Official Recall Notification U.S. Federal Boat Safety Act

Mercury Diesel Vessel Sensor Harness Replacement

Models Affected

Mercury Diesel VIP vessel sensor harness connection

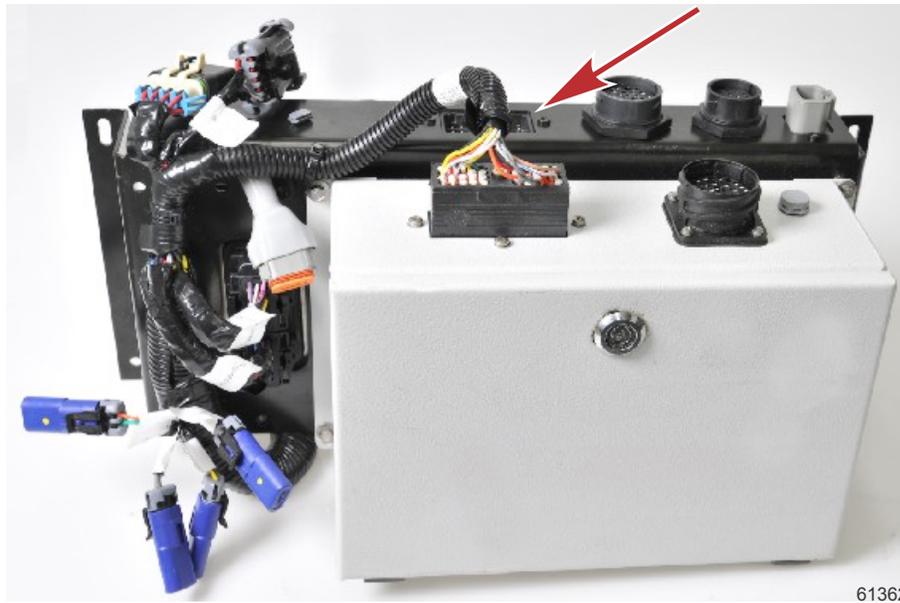
1. Locate the vessel interface panel (VIP) on the 2.0L, 2.8L, or 4.2L engines, or the vessel adapter assembly (VAA) on TDI engines. Refer to the pictures following for identification.
2. Identify the vessel sensor harness by its connection point at the VIP or VAA.

NOTE: Many installations have an extension harness between the VIP or VAA and the vessel sensor harness. The extension harness does not require replacement. Follow the extension harness to locate the actual vessel sensor harness.

3. Unplug all auxiliary sensors and devices from the harness. Loosen the Allen retaining screw and unplug the 24-pin connection from the VIP, VAA, or extension harness.
4. Connect the new vessel sensor harness 24-pin connector to the VIP, VAA, or existing extension harness. Tighten the Allen retaining screw to secure the connection.
5. Reconnect all auxiliary sensors and devices to the new vessel sensor harness, making sure all connectors seat properly.
6. Start the engine and verify function of the DTS shift actuator, trim sensor, and any other auxiliary sensors that are connected to the harness.
